ALERT SERVICE BULLETIN

429-16-31

MODEL AFFECTED: 429

SUBJECT: WHEELED LANDING GEAR COCKPIT CONTROL PANEL LIMITATIONS, CHANGE OF.

Figure 1 – Cockpit Control Panel Decal Installation

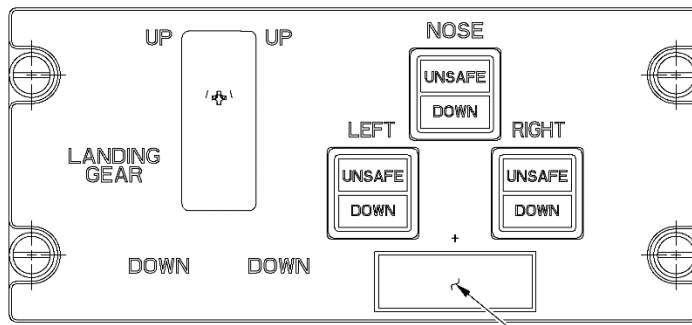
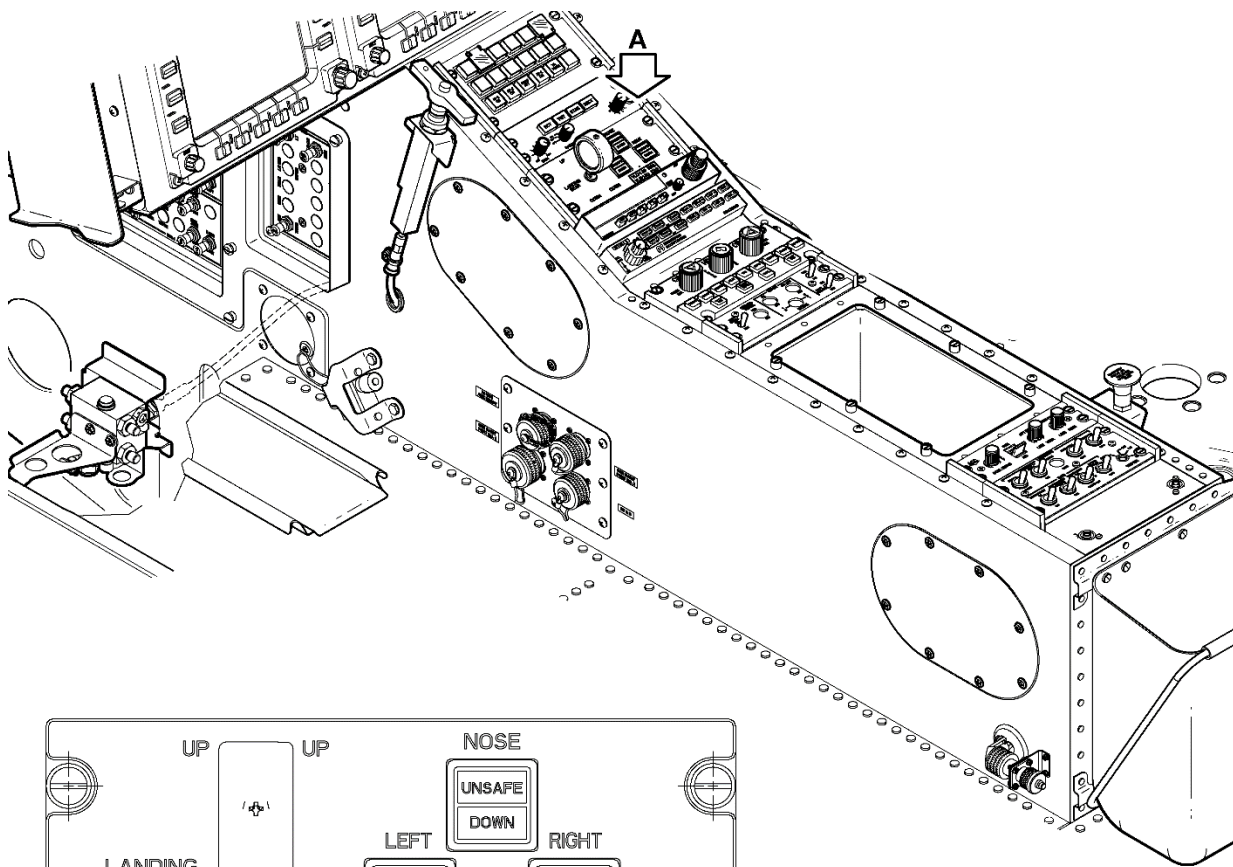
The limitation indication (VLO/VLE) on the edge-lit wheeled landing gear cockpit control panel (CCP) does not match Flight Manual Supplement (FMS), BHT-429-FMS-10, Revision 7, which has been reduced from 120 Knots Indicated Air Speed (KIAS) to 80 KIAS. This Alert Service Bulletin (ASB) is to introduce a decal that will be installed over the original panel limitations, reflecting the new limitations. Applicability of this bulletin to any spare part shall be determined prior to its installation on an affected helicopter.

1. Prepare the helicopter for maintenance.
2. Locate area on the wheeled landing gear cockpit control panel on the pedestal (Figure 1) to which decal will be applied (Figure 1, View A).
3. Install the decal (Figure 1, Detail B Post Bulletin) in the location noted on the wheeled landing gear cockpit control panel (Figure 1, View A) of the pedestal. BHT-429-MM-1 Chapter 11 for Application of decal.
4. Make an entry in the helicopter logbook and historical service records indicating compliance with **Part I** of this Alert Service Bulletin.

VLO= 120 KIAS
VLO= 140 KIAS

VLO RET= 80 KIAS
VLO EXT= 120 KIAS

DETAIL B
(PRE BULLETIN)

DETAIL B
(PPOST BULLETIN)

Figure 2 – Decal Local Manufacturing Information

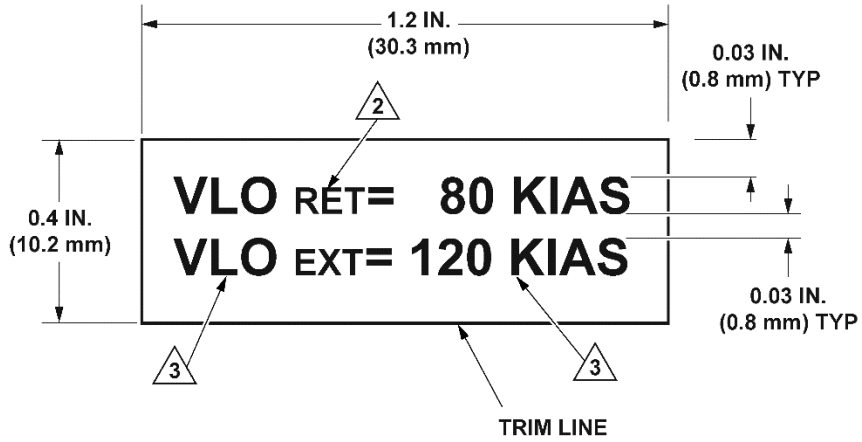
1. Part required for **Part I** of this ASB. Decal (Figure 1, Detail B) may be locally manufactured using information in Figure 2.
2. Part required for **Part II** of this ASB.

1. To comply with MIL-DIL-43719/2 type 1, class 1.
- 2 Letters to be white (color). All characters shall be 10 points (height) futura condensed.
- 3 Letters to be white (color). All characters shall be 14 points (height) futura condensed.
4. Background shall be black, color.
5. A clear gloss self-adhesive polyester or vinyl film shall be applied over the finished decal.
